# TOWN OF PLAINFIELD PLAN COMMISSION REPORT

**CASE NO.:** [PP-21-132](#)

**REQUESTED ACTIONS:** Primary Plat Approval of a 2-lot Subdivision

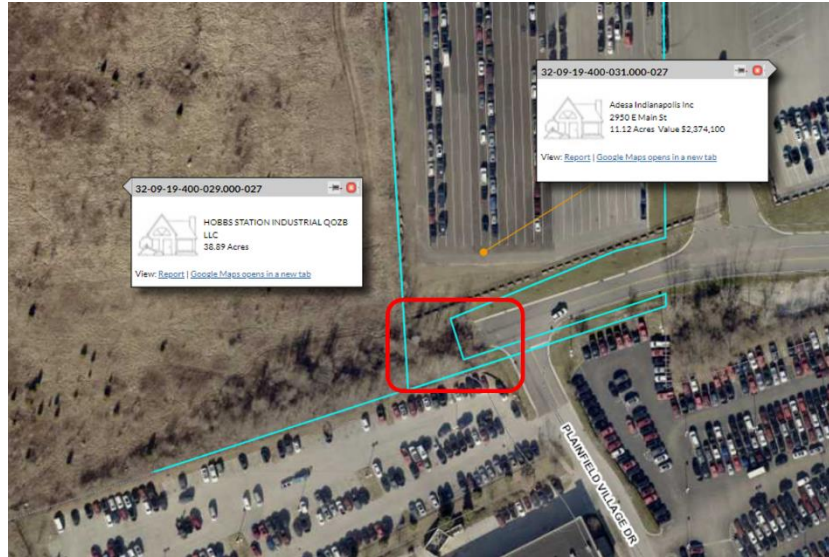
**Sample Future Lot –**  
How is access provided? Does it comply with yard requirements, use of yard restrictions, parking, landscaping, etc. for an individual site?
